2-4 Hindes Road, Harrow, HA1 1SJ	P/3833/22
----------------------------------	-----------

LONDON BOROUGH OF HARROW

PLANNING COMMITTEE

APPLICATION NUMBER: P/3833/22
VALIDATION DATE: 16/11/2022
LOCATION: 2-4 HINDES ROAD, HARROW
WARD: MARLBOROUGH
POSTCODE: HA1 1SJ
APPLICANT: MR RAJ RAITHATHA
AGENT: MJP PLANNING
CASE OFFICER: FERGUS FREENEY
EXTENDED EXPIRY DATE: 29/06/2023

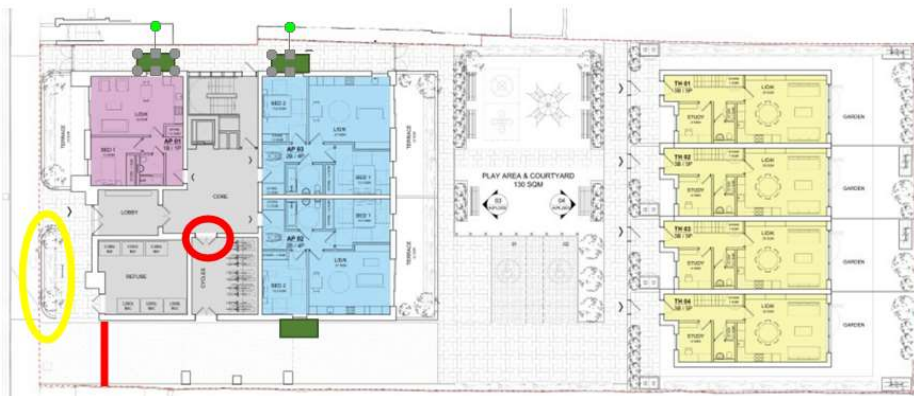
This development cannot obtain a secured by design accreditation, with the submitted plans, therefore this is an objection to these plans.

The ground floor private room windows must have a 1 meter wide by 1 meter high, mature, dense defensible planting. To protect this windows from prying and people standing close t, as marked green on above plans.

The planned development creates an under croft area, which must be gated where the red line is shown above plan, this gate will need to be a tested and certified LPS1175 SR2 (B3) vehicle gate.

The area marked with the yellow oval at the front of the building needs more explanation, it could create an area which attracts ASB and facilitates crime.

There is also a lot of double door sets shown in the plans, single leaf doors are more reliable with deterring crime.

PLANNING OFFICER COMMENTS: *The scheme has been revised to include a gate at the undercroft and a condition requiring Secure By Design Accreditation will be imposed.*
